STEIN/COLLEGE SUBDIVISION

Engineering Comments: FINAL PLAT COMMENTS (should be addressed prior to submitting the FINAL PLAT for review and/or signature by the City Engineer):

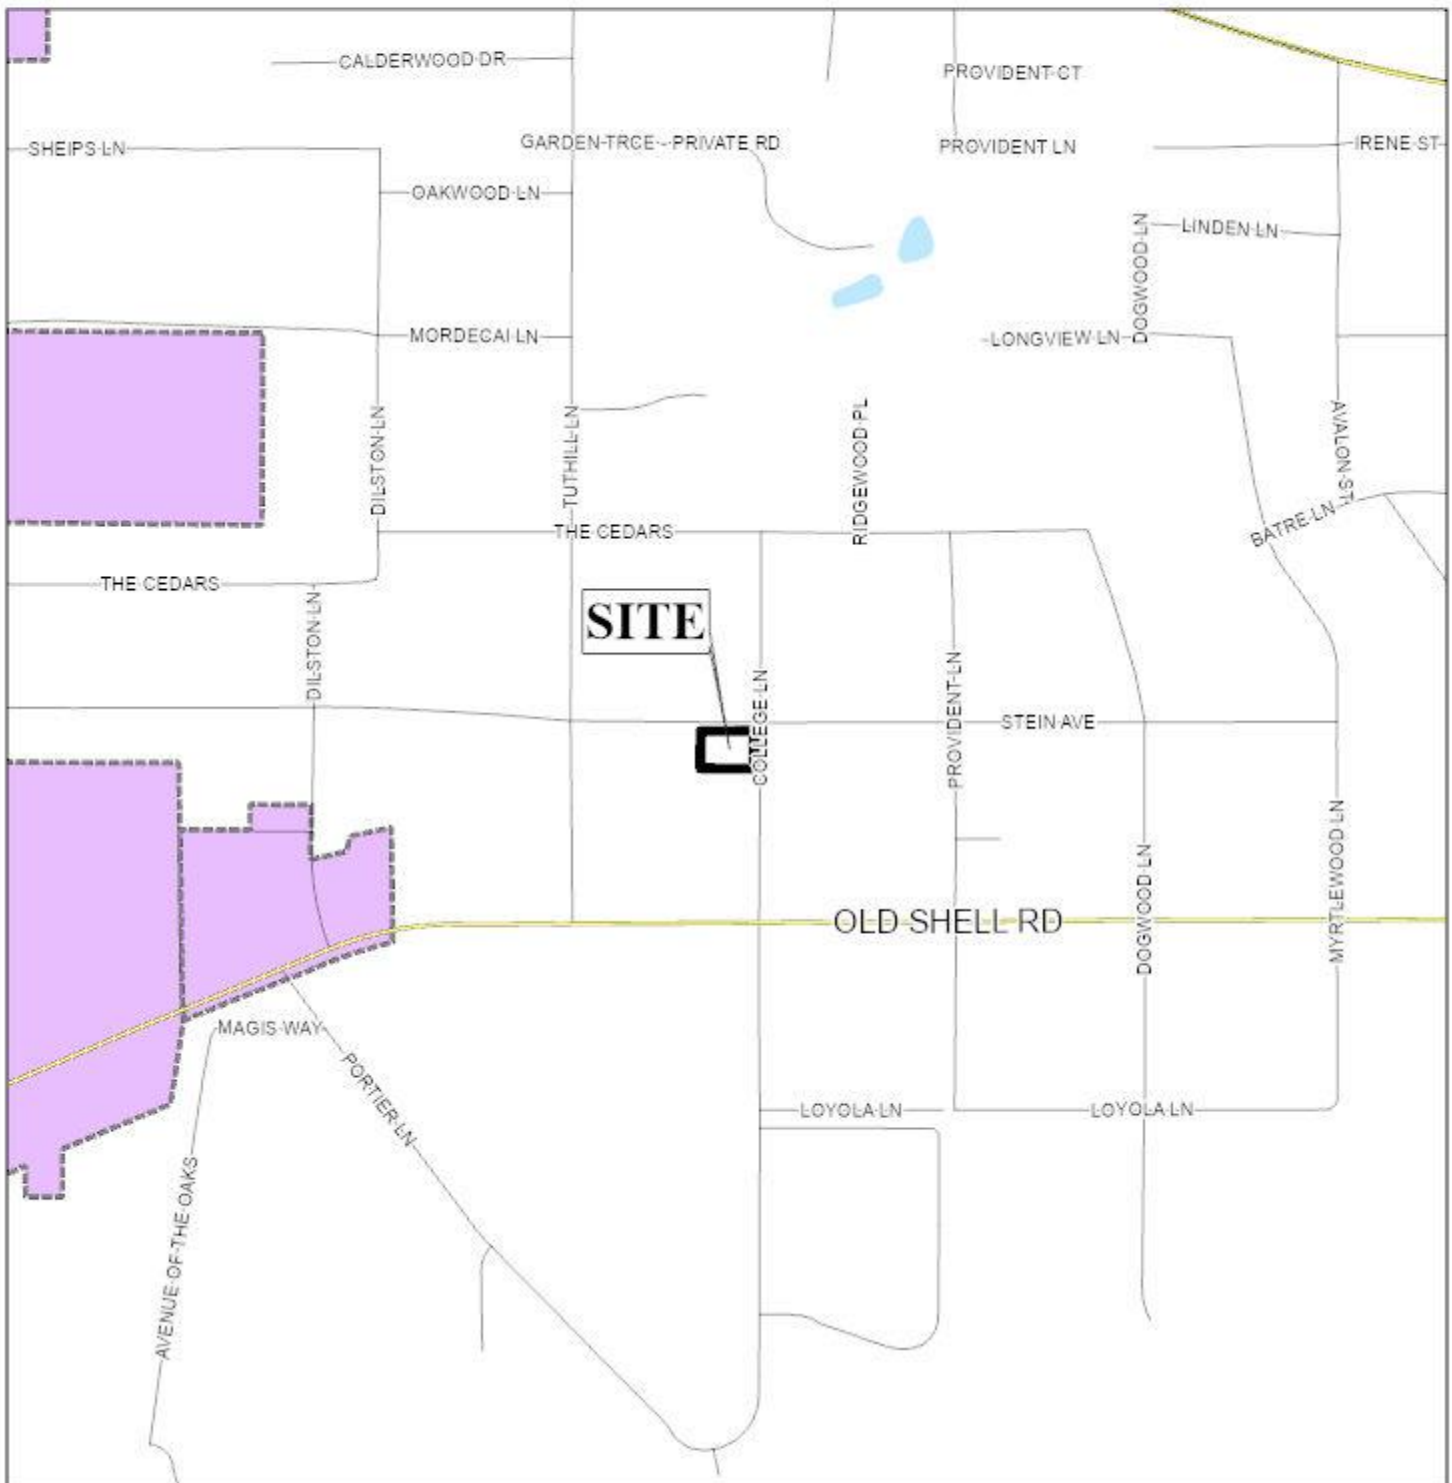
The proposed lot has frontages along Stein Avenue and College Lane, both minor streets with curb and gutter, each requiring a 50-foot right-of-way. The preliminary plat illustrates sufficient dedication for each frontage, including dedication of a 25-foot curb radius at the intersection of Stein Avenue and College Lane, thus no additional dedication is required. This information should be retained on the Final Plat, if approved.

The proposed lot will exceed the minimum size requirements for lots served by public water and sanitary sewer systems, and it is appropriately labeled in both square feet and acres. This information should be retained on the Final Plat, if approved; or, provision of a table on the Final Plat with the same information may suffice.

The 25-foot minimum building setback line is illustrated along College Lane, per Section V.D.9. of the Subdivision Regulations, but a 20-foot minimum building setback line is illustrated along Stein Avenue. Section 64-4.D.3. of the Zoning Ordinance allows a reduced minimum building setback for corner lots, the size of which depends on the primary frontage of the subject site and the primary frontage of the abutting rear lot. In reviewing aerial images, the 20-foot minimum building setback along Stein Avenue is sufficient, but the applicant should be aware that the primary frontage of a future dwelling will be limited to facing College Lane unless a 25-foot minimum setback is provided along both street frontages. Nevertheless, a reduced minimum building setback line along Stein Avenue will require a waiver of Section V.D.9. of the Subdivision Regulations for approval.

It should be noted that an address ticket has been assigned to the subject site by the Engineering Department, but is for a house number along Stein Avenue. Limiting a dwelling's primary frontage to College Lane may require an amendment to the address ticket to reflect a house number along this street, not Stein Avenue.

Finally, for access management, a note should be placed on the Final Plat, if approved, stating Traffic Engineering comments.

- 1) Retention of the 50-foot rights-of-way, along with any required dedication, along Stein Avenue and College Lane;
- 2) Retention of the 25-foot corner radius at the intersection of Stein Avenue and College Lane, after any required dedication;

- 3) Retention of the lot's size in acres and square feet on the Final Plat, or provision of a table on the Final Plat providing the same information;
- 4) Retention of the 25-foot minimum building setback line along College Lane, in compliance with Section V.D.9. of the Subdivision Regulations;

- 5) Retention of at least the 20-foot minimum building setback line along Stein Avenue, or revision of the plat to illustrate a 25-foot minimum building setback line if a Stein Avenue address is retained;
